PLAN CHANGE REQUEST

1. PROJECT: WALMART PICKUP EXPANSION ADDRESS: 310 31ST AVE
2. OWNER: WAL-MART RE BUSINESS TR 2403 EMAIL: jose.castro@wdpartners.com
3. DESIGN ENGINEER: GALLOWAY EMAIL: brandonalley@gallowayus.com

START CONSTRUCTION CHANGE DIRECTIVE CCD#7

START CONSTRUCTION CHANGE DIRECTIVE CCD#8

SHEET:
CS1A

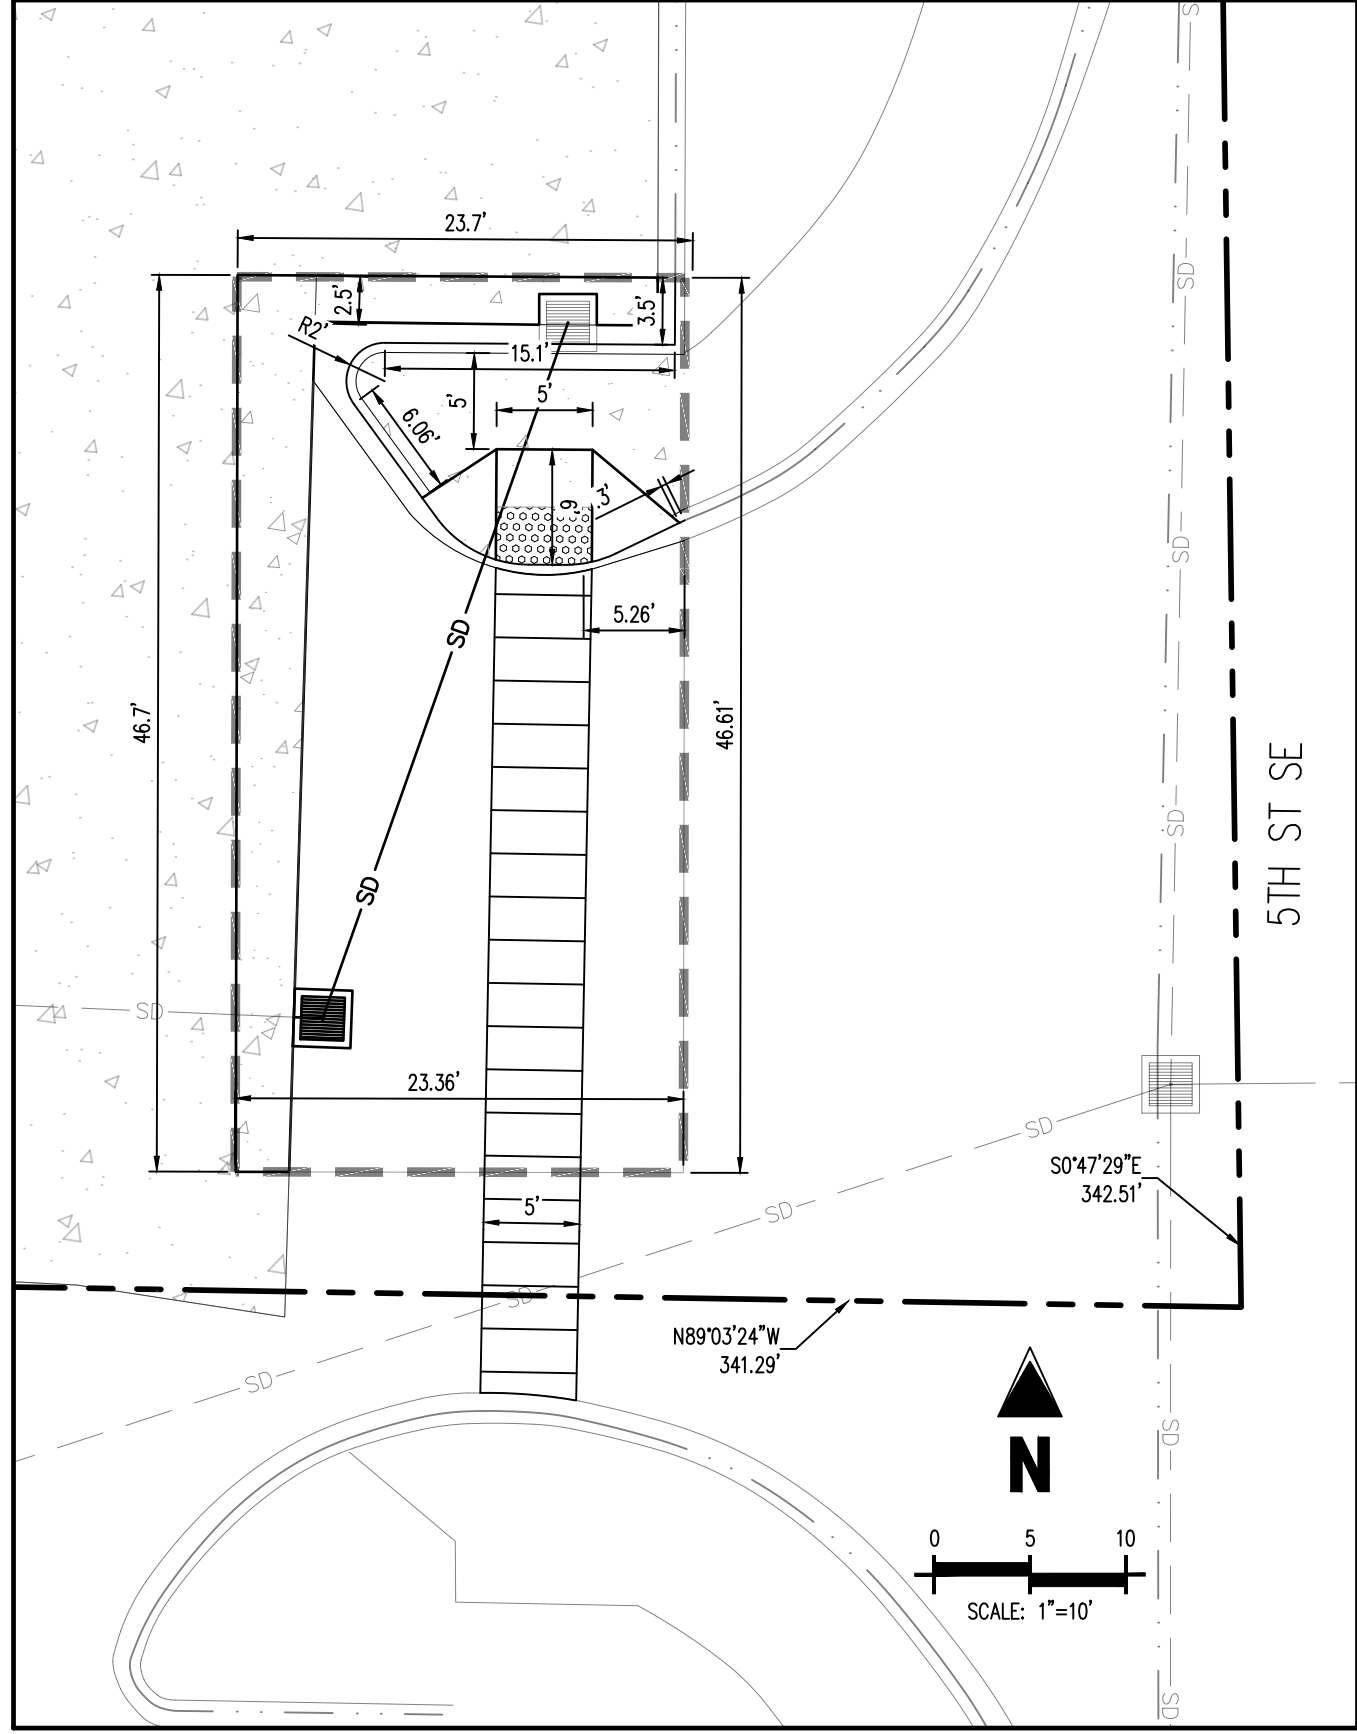
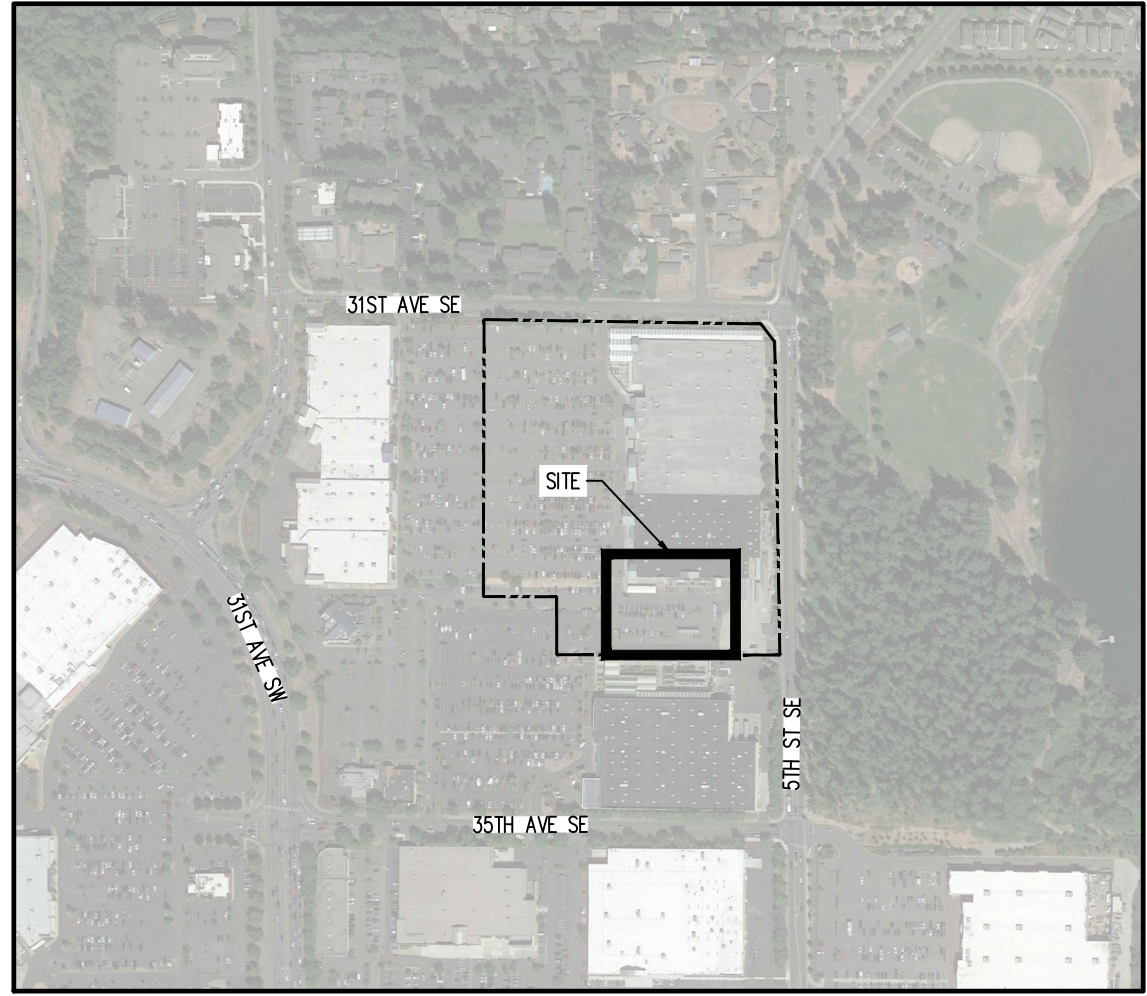
CS1A: HORIZONTAL CONTROL PLAN

1. Sheet Added

SITE DETAILS
SHEET: CS3

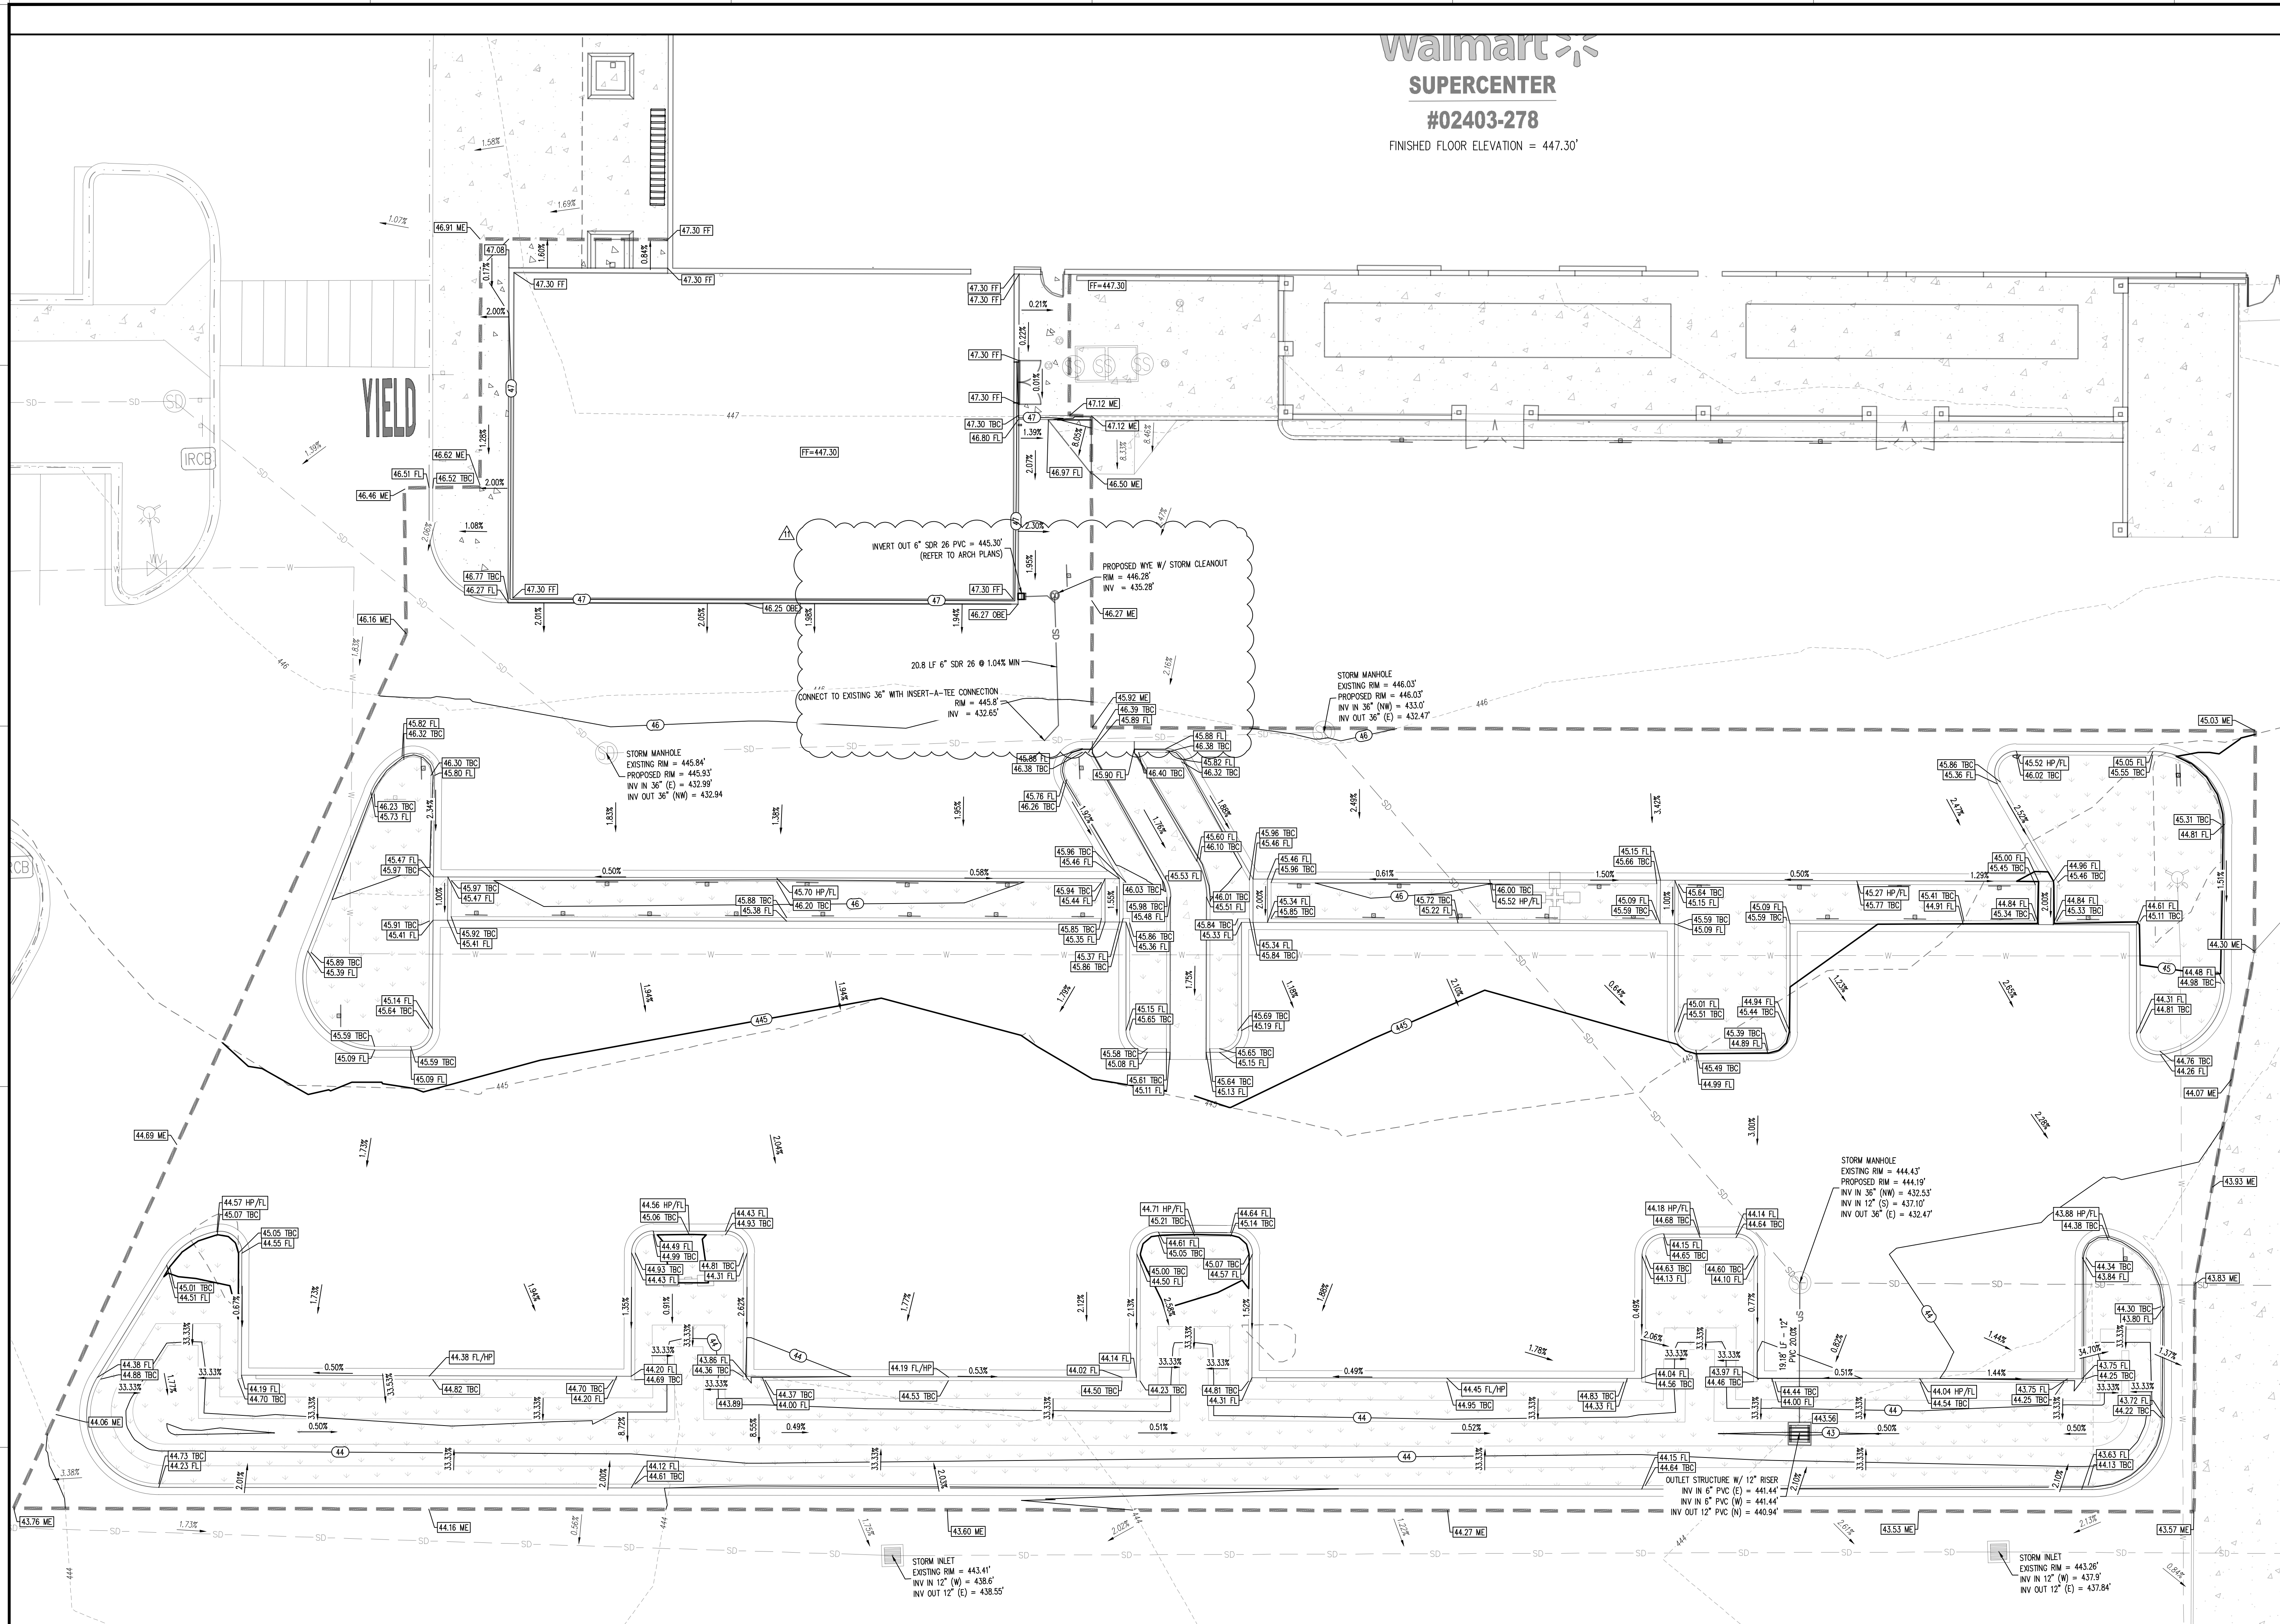
CS3: SITE DETAILS

1. Parking stall lengths revised.
2. Add "One Way Do Not Enter" signage detail.
3. Add Type "A" Concrete Curb and Gutter detail.
4. Add Concrete Sidewalk detail.
5. Add ADA Ramp in Sidewalk detail.
6. Add Projected Curb Ramp Passing through Parking Stalls detail.
7. Add Concrete Curb Chase detail.

GRADING PLAN

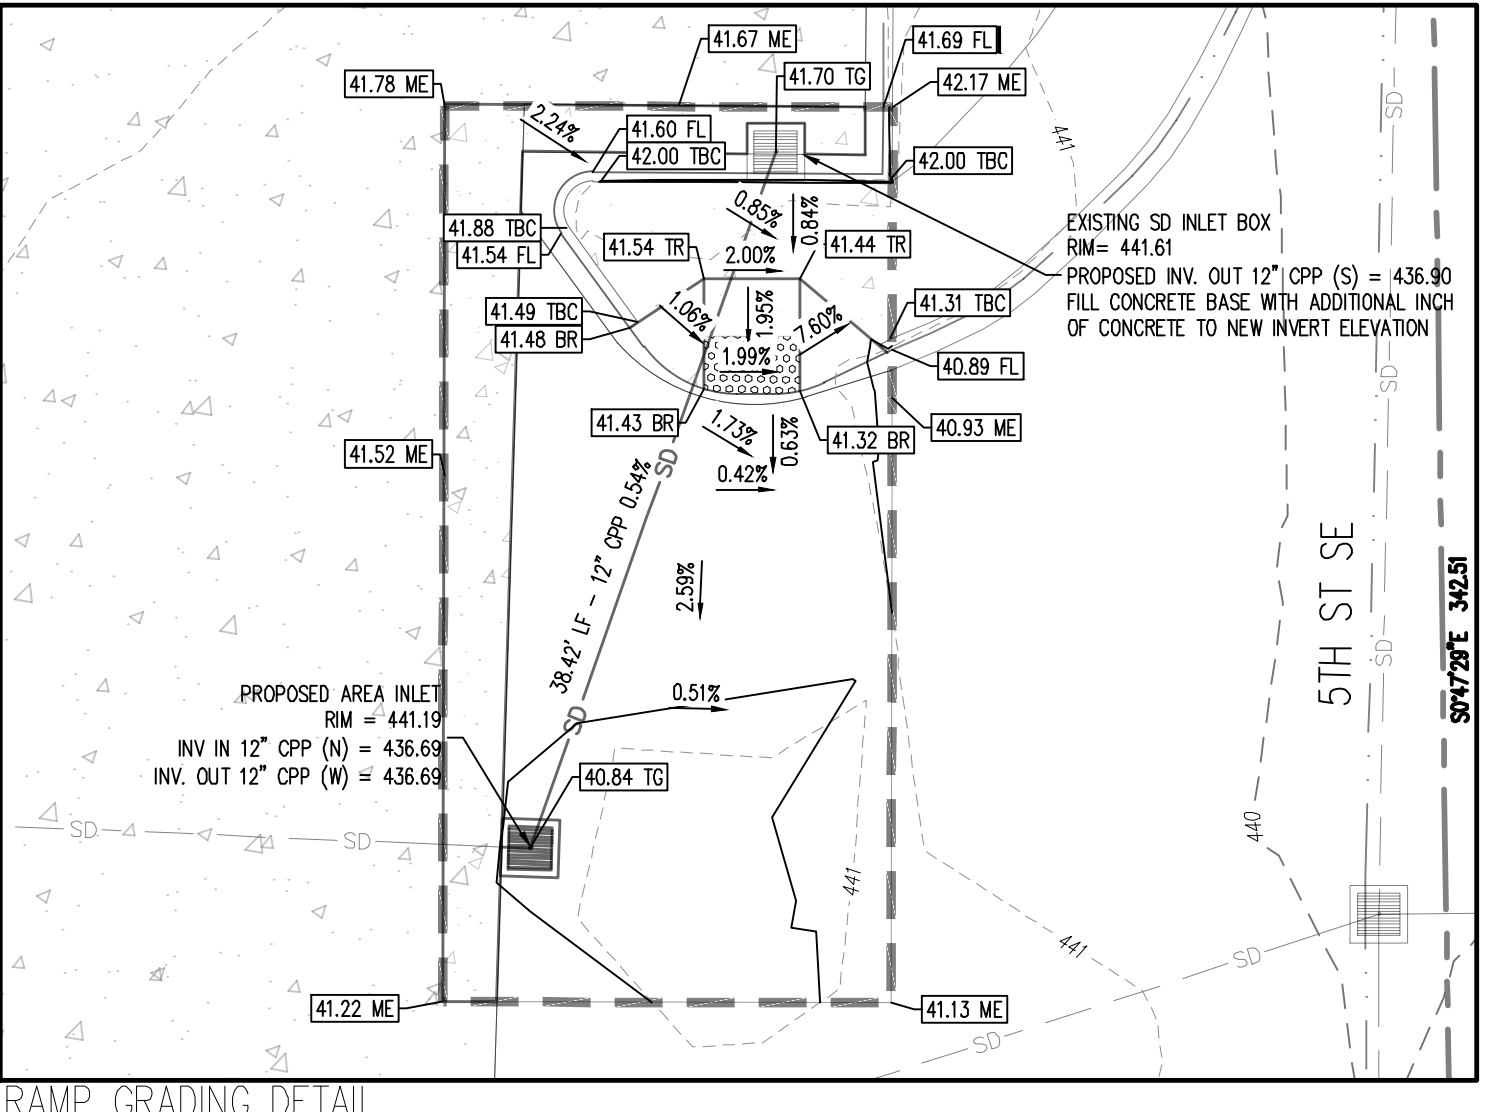
6004 – CS4 Grading Plan

1. Add roof drain routing from building.
